TT8045EN, Rev. A
August, 2018
Page 1 of 4

SUBJECT: Incorrect Calibration Setting for Primary Mode: Gears in Freightliner Custom Chassis Corporation (FCCC) Motorhome Chassis

MODELS AFFECTED: FCCC Motorhome Chassis MC, XBS, XCR, and XCS with 2500MH Series Transmission

Figure 1. Example of the Incorrect Setting Prior to Reflashing

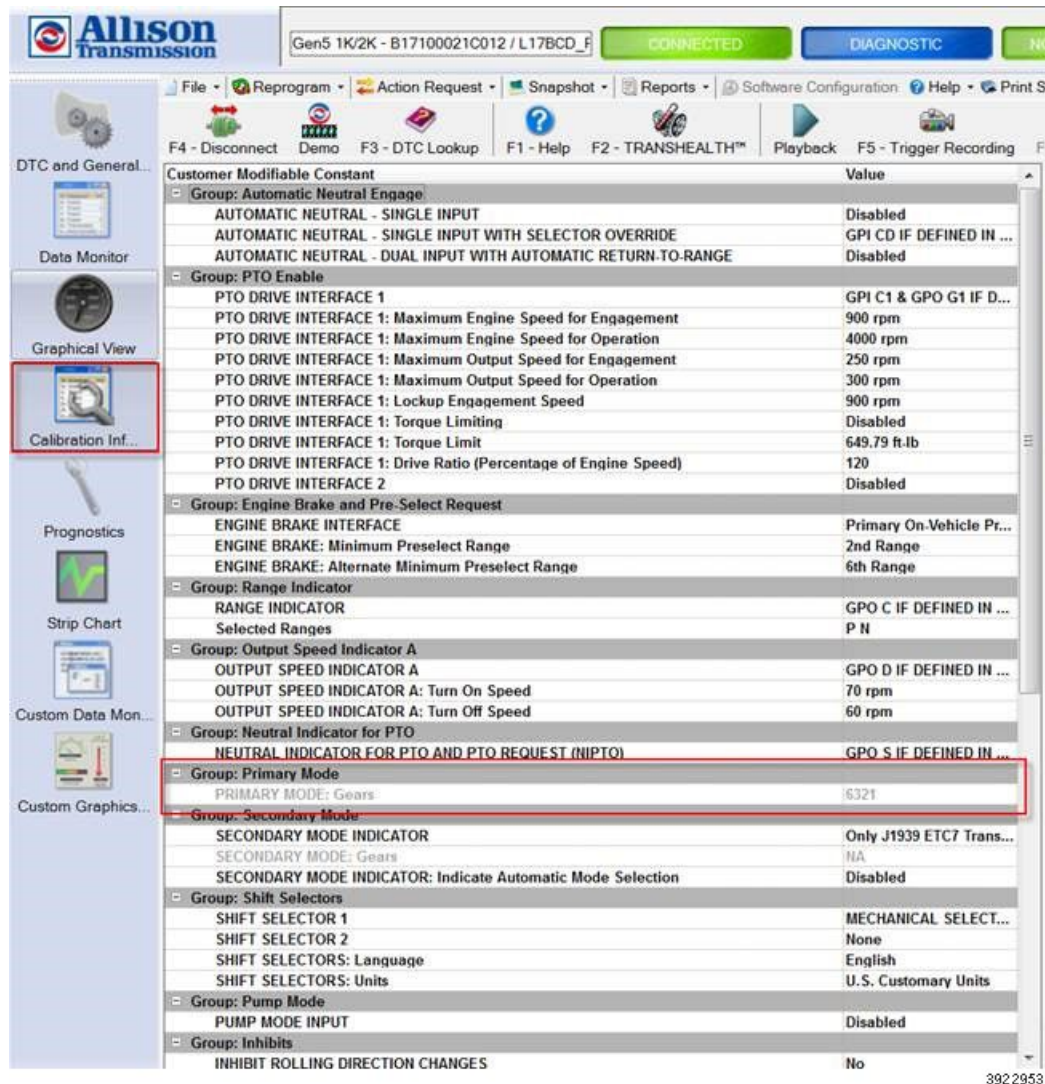
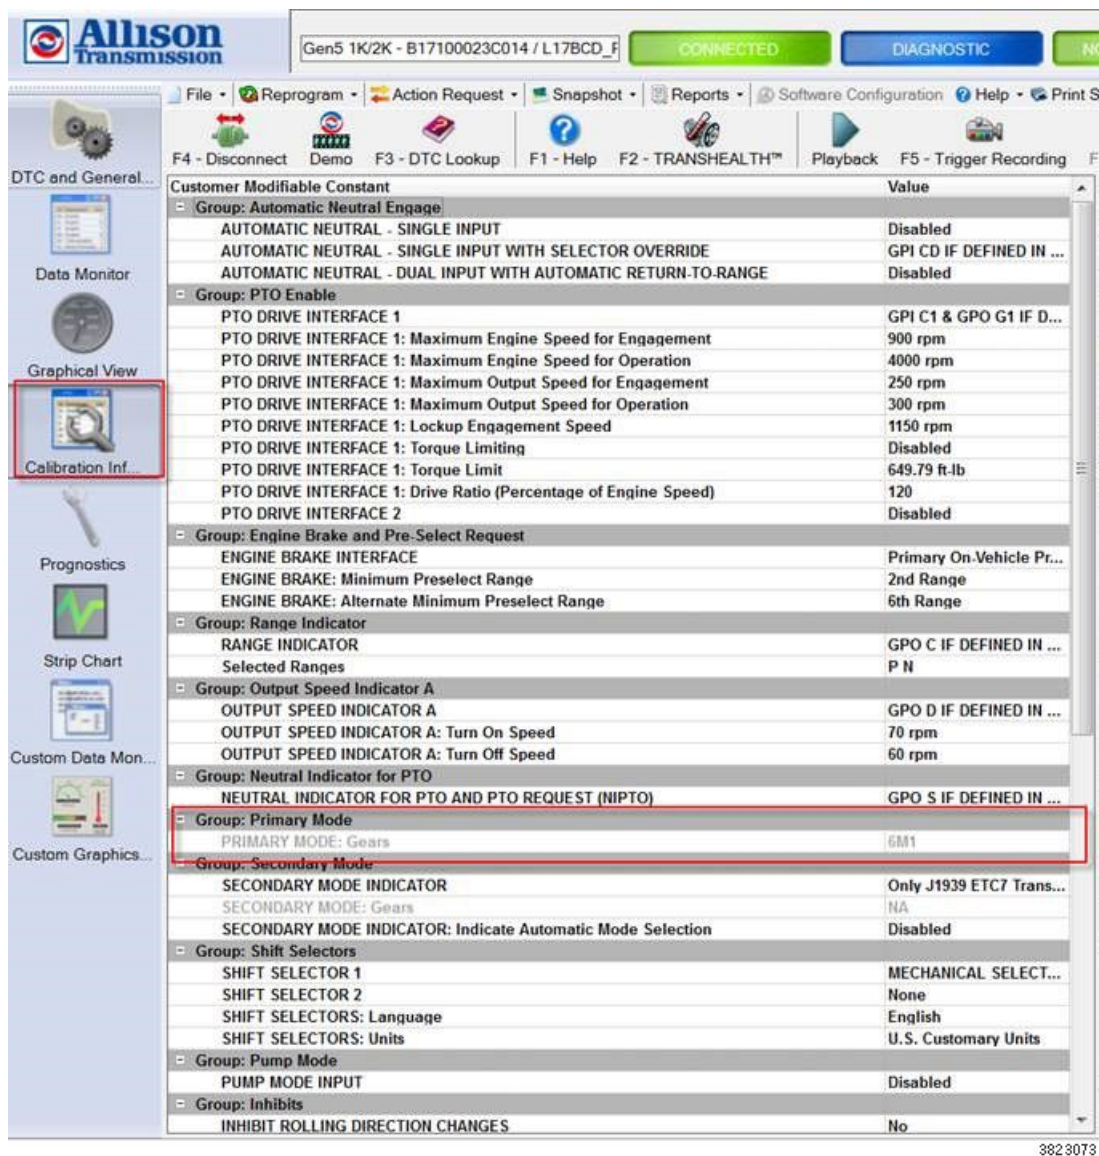
The Primary Mode: Gear calibration setting was **incorrectly** set to 6321 instead of the **correct** setting of 6M1 for 6-speed units in the affected population. 5-speed units were **incorrectly** set to 5321 instead of the **correct** setting of 5M1 for units in the affected population. This correction will allow preselect downshift, which allow an increase in engine speed, thus increasing the amount of engine braking.

Connect to the TCM using Allison DOC® to verify that the calibration parameters are set to correct settings. Once connected to the TCM, select the Calibration Information icon. Look at Group: Primary Mode to verify the correct setting. Figure 1 is an example of the **incorrect** setting prior to reflashing. Notice the Value for Primary Mode: Gears is set to 6321. The value may be 5321 on some of these motorhomes.

Figure 2 is an example of the **correct** setting after reflashing. Notice the Value for Primary Mode: Gears is set to 6M1. The value may be 5M1 on some of these motorhomes.

NOTE: 6-speed transmission will use 6M1 and 5-speed transmissions will use 5M1.
